Re: Response to Recommendations
USEPA CCR Impoundment Assessment DRAFT Report
Johnsonville Fossil Plant (JOF)
New Johnsonville, Tennessee

As requested, Stantec has reviewed the DRAFT report *Coal Combustion Residue Impoundment Dam Assessment Report, Johnsonville Fossil Plant, Tennessee Valley Authority, New Johnsonville, Tennessee, dated May 2012* prepared by Dewberry and Davis, LLC (Dewberry) for the United States Environmental Protection Agency (USEPA). The purpose of this letter is to address Dewberry's conclusions and recommendations pertaining to structural stability, hydrologic/hydraulic capacity, and technical documentation; and to provide additional supporting information relative to ongoing plant improvements, further analysis, and planned activities where applicable. Dewberry's recommendations and Stantec's corresponding responses are listed below. The recommendations and responses apply to Ash Disposal Area 2.

**Section K - Ash Disposal Area 2
Johnsonville Fossil Plant
New Johnsonville, Tennessee**

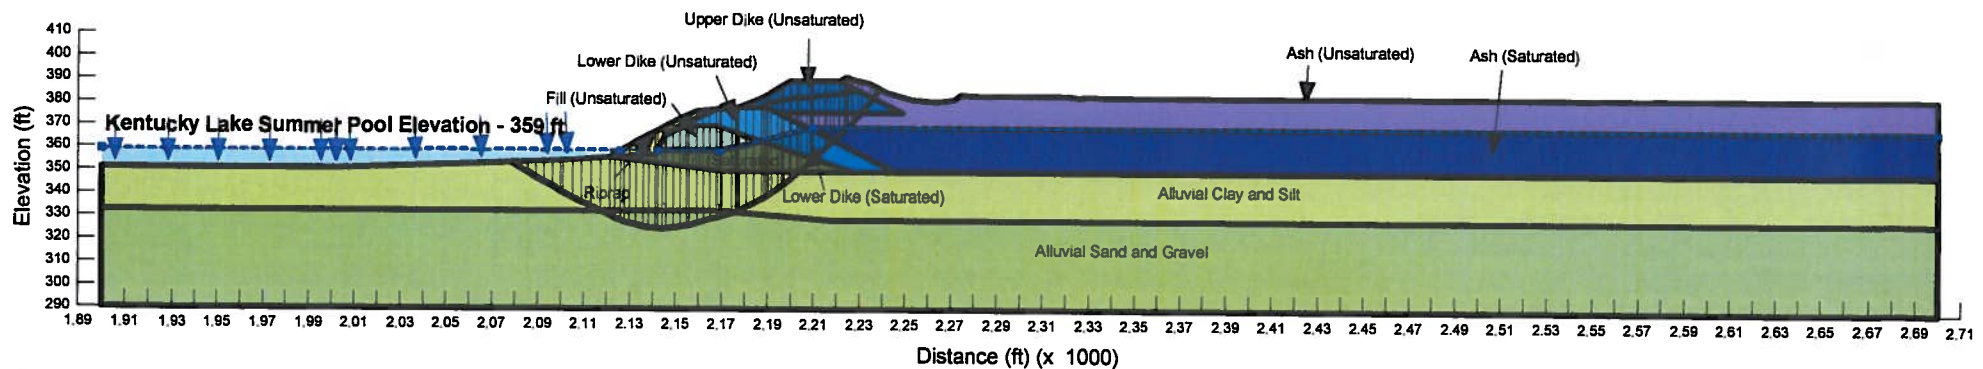
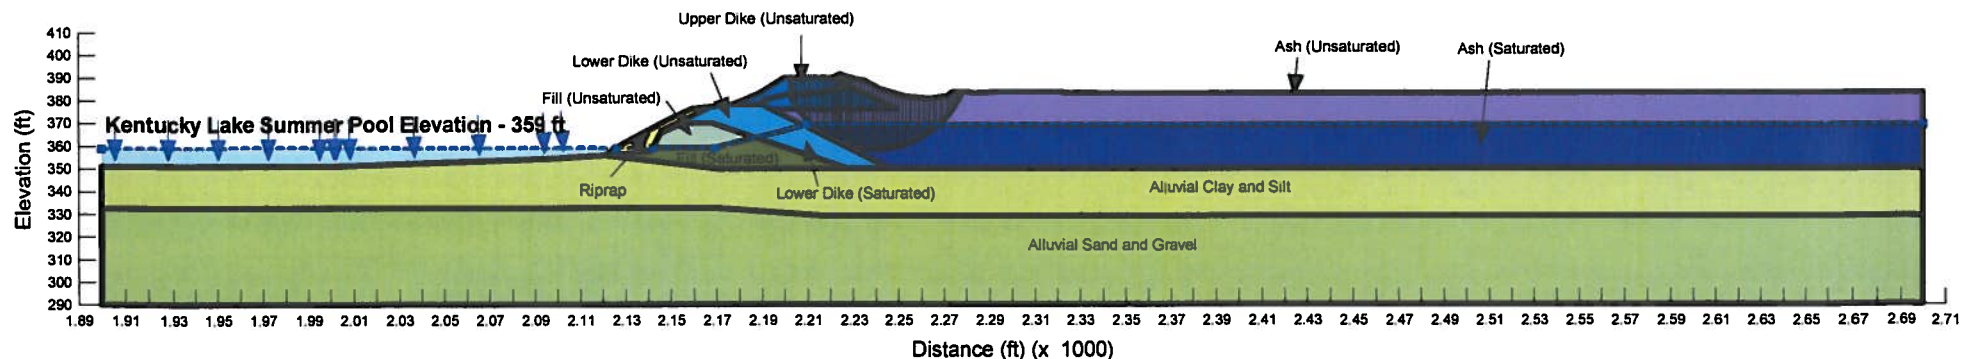
Dewberry Report Section 1.2.3 2): If liquefaction is indicated by the analysis, perform a post-earthquake analysis using static slope stability analysis using reduced shear strengths.

Stantec Response: Based on the results of the liquefaction potential assessment, residual strengths were assigned to the liquefied materials and post-earthquake static stability analysis was performed for Section K. A description of the methodology and the results (slope stability cross section, including table of material parameters) are attached. The results indicate that Section K has a factor of safety greater than or equal to the target threshold value of 1.0; thus, the slope is judged to remain stable and will not undergo significant liquefaction-induced deformations due to the 2,500-year earthquake.

TVA JOF Ash Disposal Area 2, Source = All Other Zones, Mw = 7.05, PGAsoil = 0.1012 g, Return Period = 2500 years, SPT Data, NCEER Simplified Method, No Fines Correction if Zero Blowcounts, No Fines Correction if Fly Ash (ML)

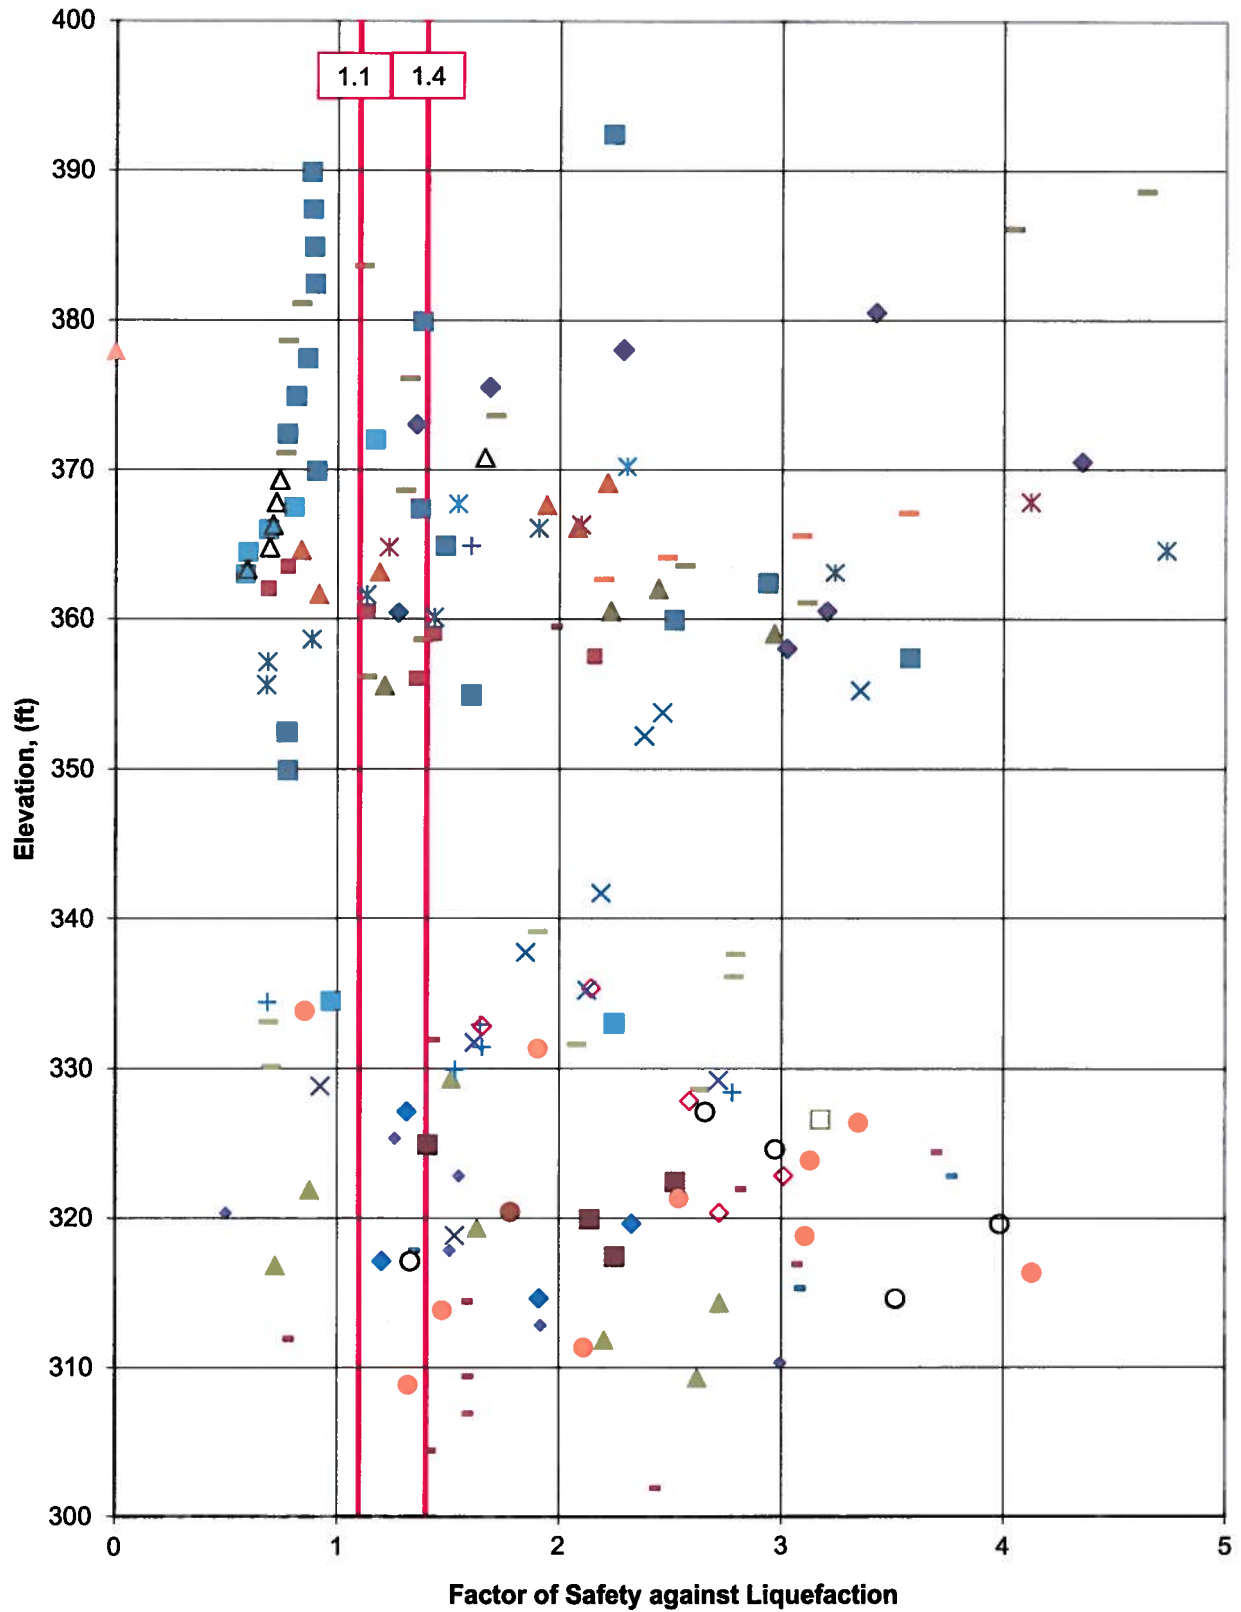
Dewberry Report Section 1.2.3 1): Perform a quantitative liquefaction analysis of embankment sections overlying very loose ash.

Stantec Response: Stantec performed a liquefaction potential assessment based on ground motion estimates for the 2,500-year earthquake scenarios, Standard Penetration Test borings, and corresponding laboratory test results. A description of the methodology and the results (ground response analysis and factor of safety against liquefaction versus elevation) are attached. Consistent with previously submitted seismic stability analyses, Section K was analyzed and the following materials are anticipated to undergo liquefaction for the 2,500-year earthquake: Ash (Saturated), Alluvial Sand and Gravel.
